Motor Ships "FELLA", "FELTRE", "CELLINA" and "RIALTO".

Revised plan of Simplex rudder submitted, in duplicate, by the Hamburg Surveyors.

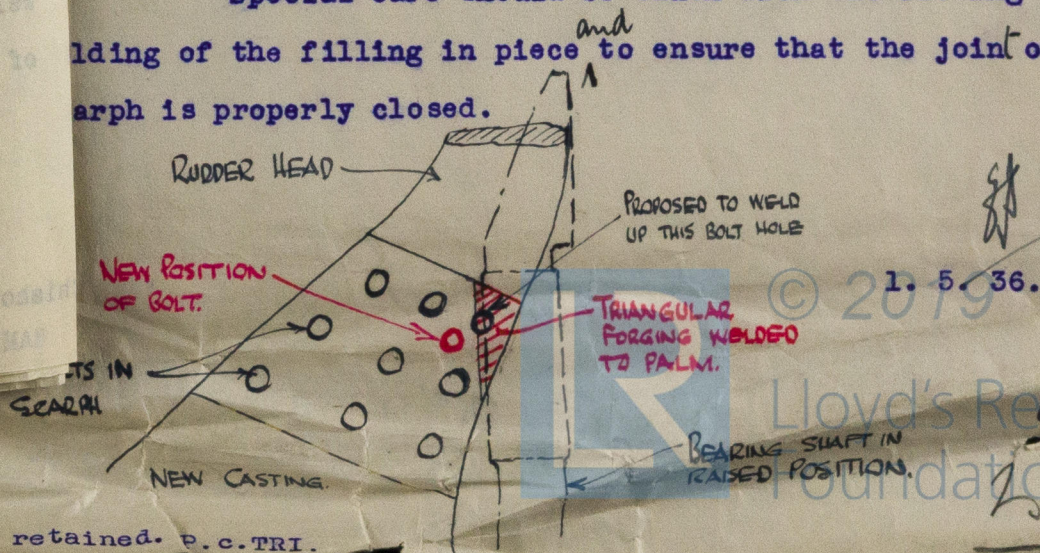
The present ordinary rudder is to be replaced by one of the Simplex type. It is proposed, however, to retain the existing rudder head from the scarp upwards, and, on the casting forming the upper part of the new rudder, make a palm to take this scarp. With this arrangement it will be necessary, to facilitate the unshipping of the bearing shaft, to cut away the upper corner of the palm on the new casting and to modify the position of one of the bolts. The corner where cut away will be filled in by a triangular forging welded to the palm on the rudder head - see sketch below.

The strength of the scarp as proposed is not impaired, but the nature of the proposal is such <sup>that</sup> as it is considered the owners' consent should be obtained.

It is submitted the Surveyors be informed that the scantlings and arrangements as shown and amended on the plan will be approved, provided they be carried out to their satisfaction, and the Owners' consent be obtained to cutting away the corner of the palm forming the scarp on the rudder body casting, as proposed.

Special care should be taken with the fitting and welding of the filling in piece <sup>and</sup> to ensure that the joint of the scarp is properly closed.
